**Technical Service
BULLETIN**

DOOR CHECK POPPING NOISE

'04 – '06 Sienna

REVISED
NV003-07
NVH

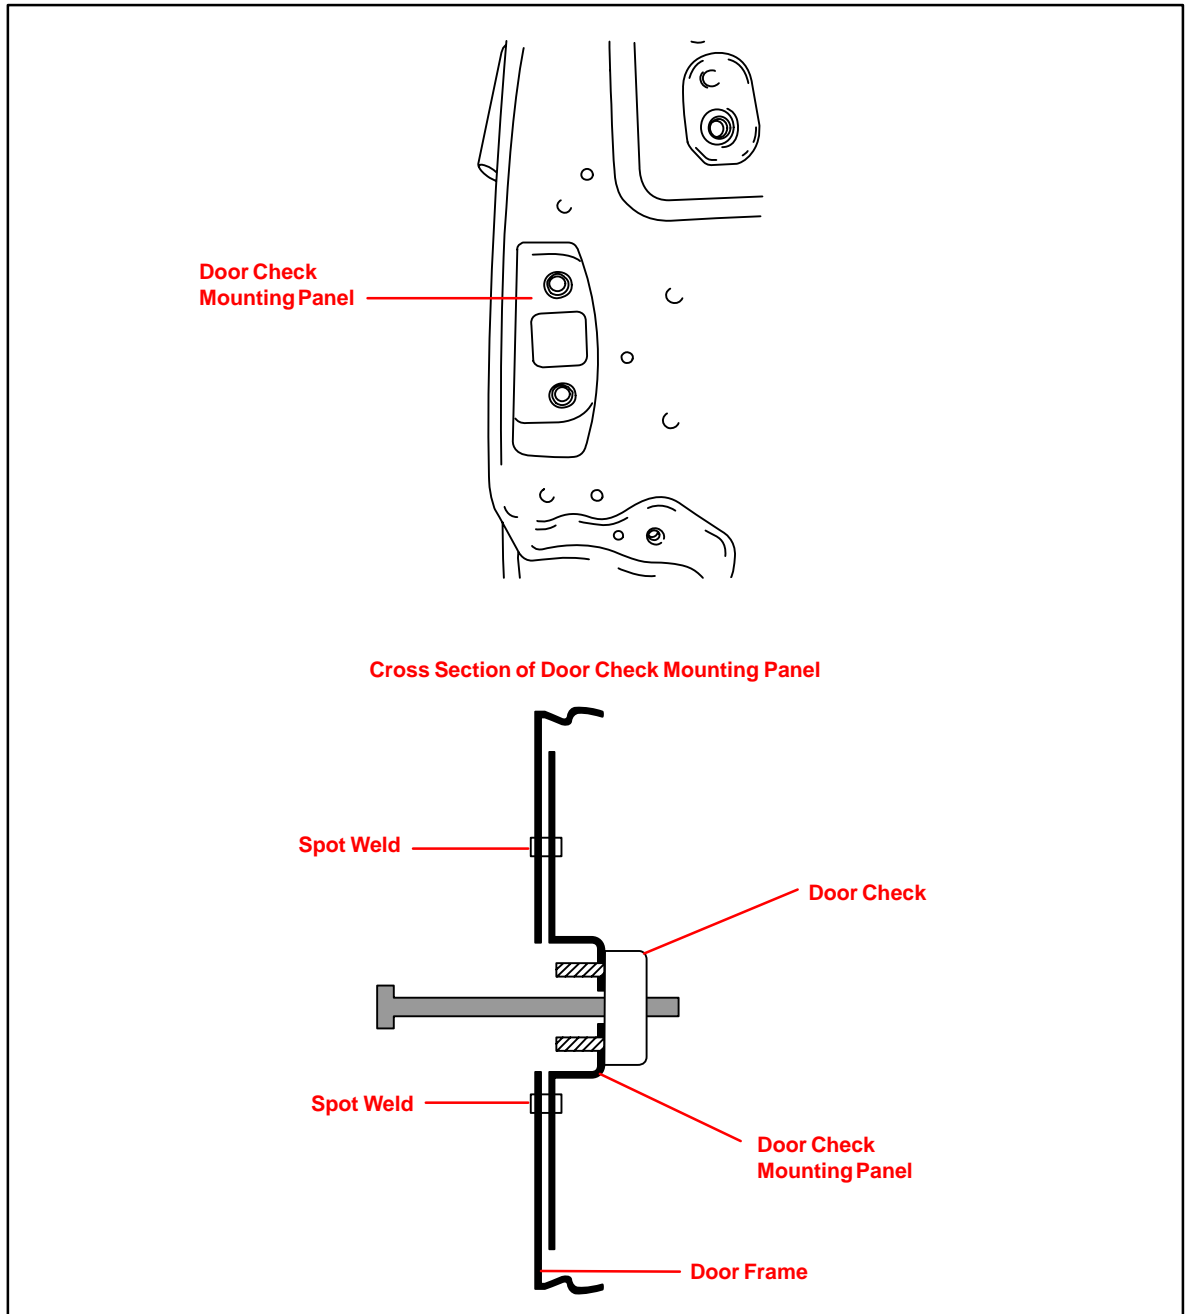
Inspect the door frame around the door check mounting area.

- If a spot weld or check mount area is cracked or split, the following repair method **CANNOT** be performed and the door assembly **MUST** be replaced.

- If a door is to be replaced, *all hemming flanges and body panel seams MUST* be sealed with body seam sealer prior to painting the door assembly.

- If a spot weld has separated, have a body shop perform the following procedure.
